SAS SUPERSTRUCTURE - CONDUIT PLAN

CONTRACT CHANGE ORDER NO. 42
 SHEET X OF XX

SAS SUPERSTRUCTURE ROADWAY EASTBOUND LIGHTING AND ELECTRICAL SYSTEMS
 SCALE 1:200

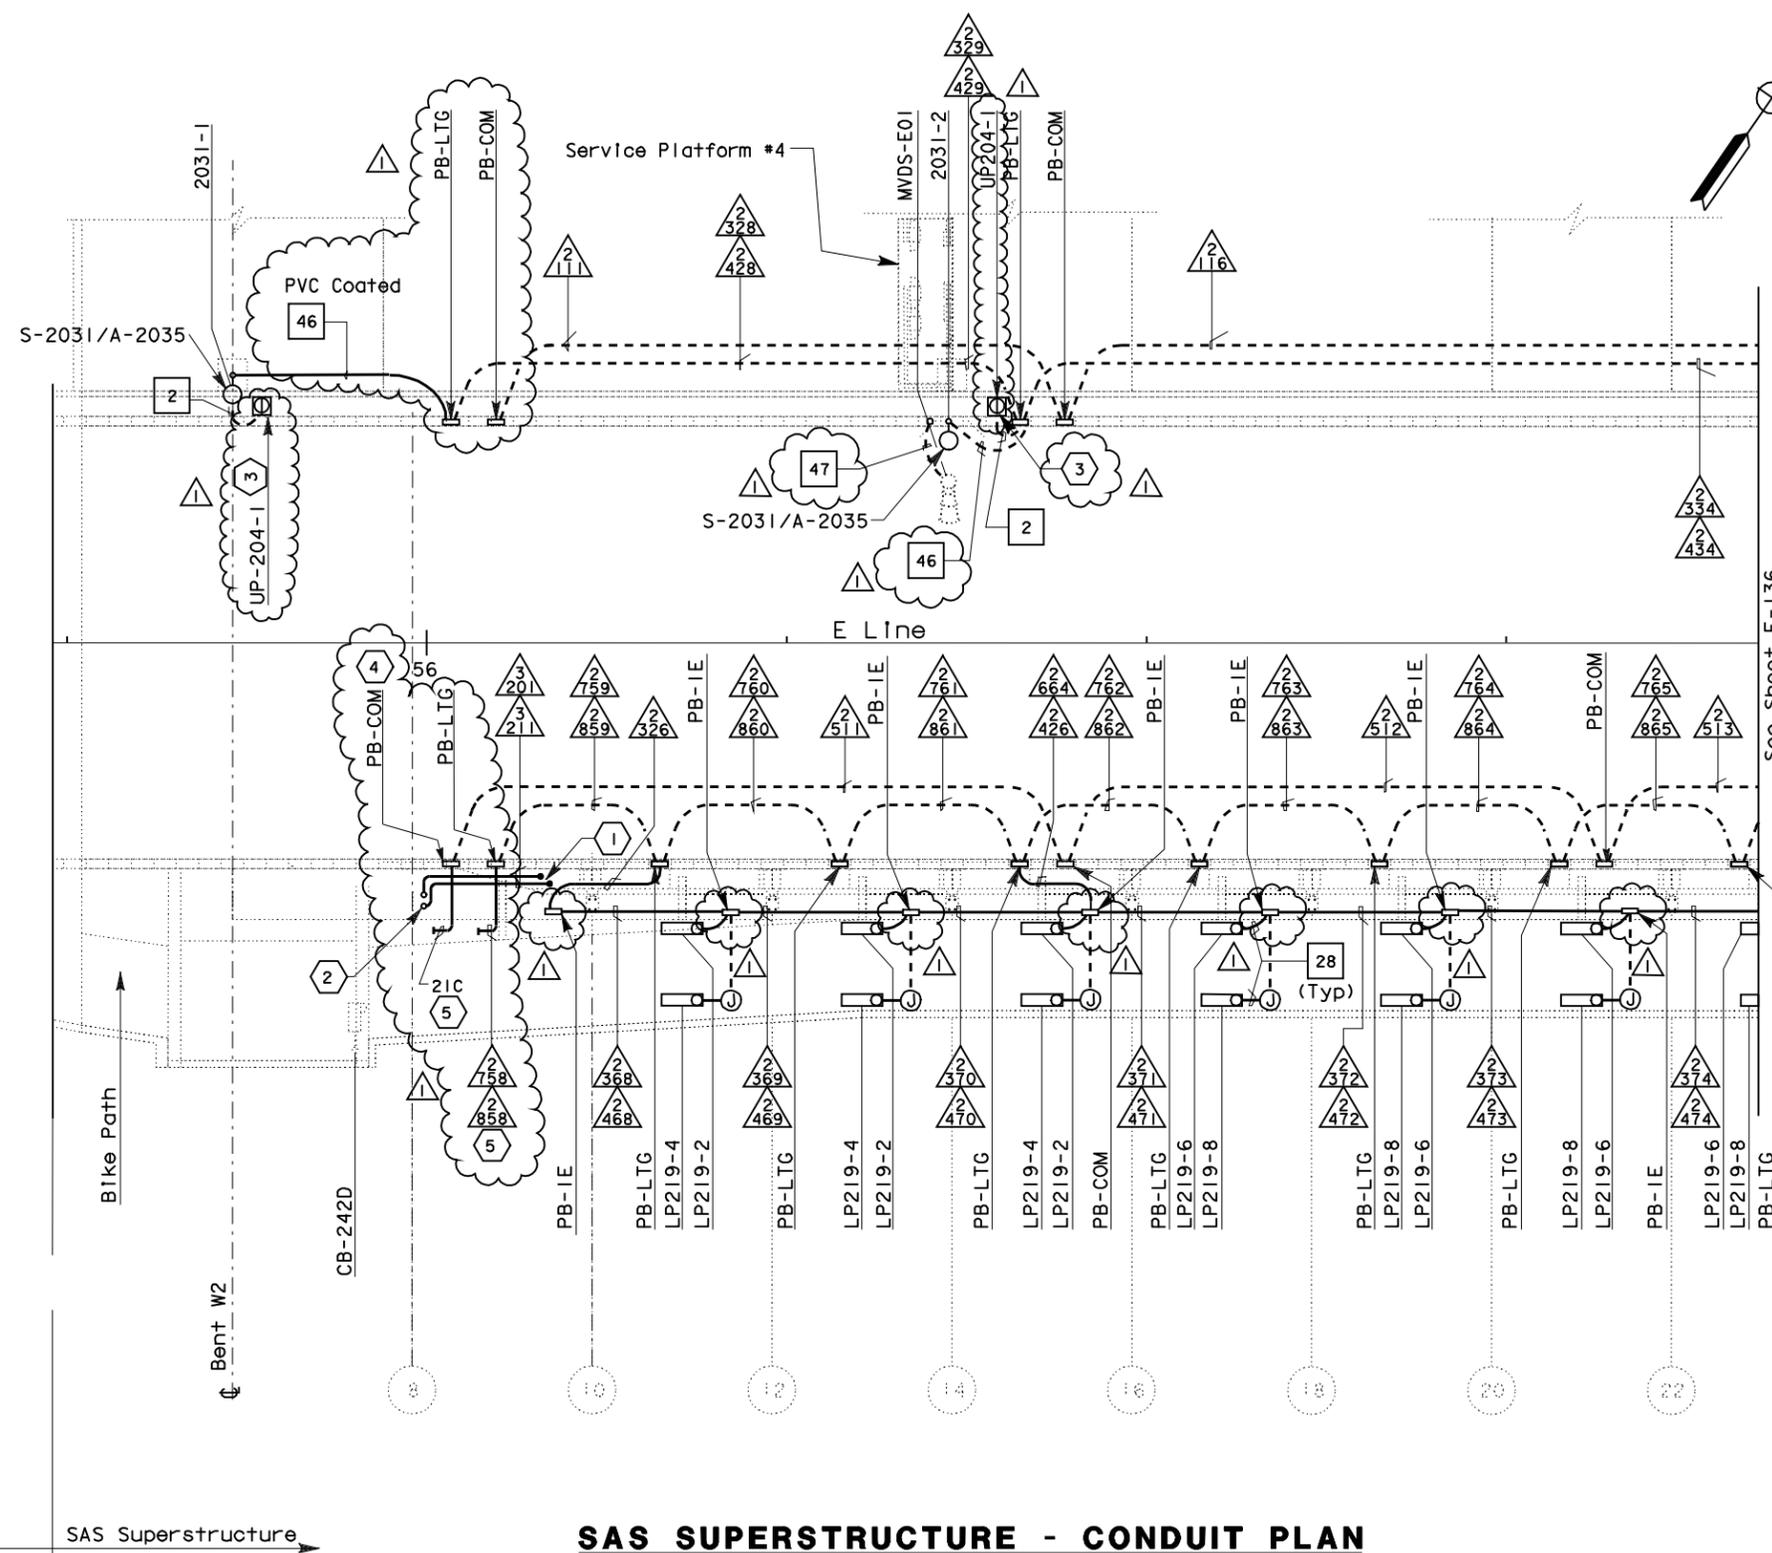
MARK	DATE	DESCRIPTIONS	BY	CK	CCO
1	8-06-07	Revision to misc. electric work. Replace bike path pull box to PB-IE per RFI-218. Change conduit types to light pole and from MVDS per RFI-565, RFI-261 is superseded by RFI-565. Change roadway barrier receptacle type per RFI-242. Relocate pull boxes and delete bike path, belvedere lighting, call box and add sheet notes 4 and 5 per RFI-561 and RFI-591.	MP	RR	42

- SHEET NOTES:**
- 1 Conduit from barrier pull box or other equipment down into Gilder Box, see sheet E-181.
 - 2 For conduit to suspension cable lighting, see sheet E-226.
 - 3 Roadway Barrier Receptacle, see Detail 1, sheet E-162.
 - 4 The Contractor shall coil sufficient length of cable (approximate 30 meters) inside PB-COM for termination by others. The Contractor to verify length.
 - 5 The Contractor to provide PVC coated conduit out from barrier, provide cap at end of conduit for future use.
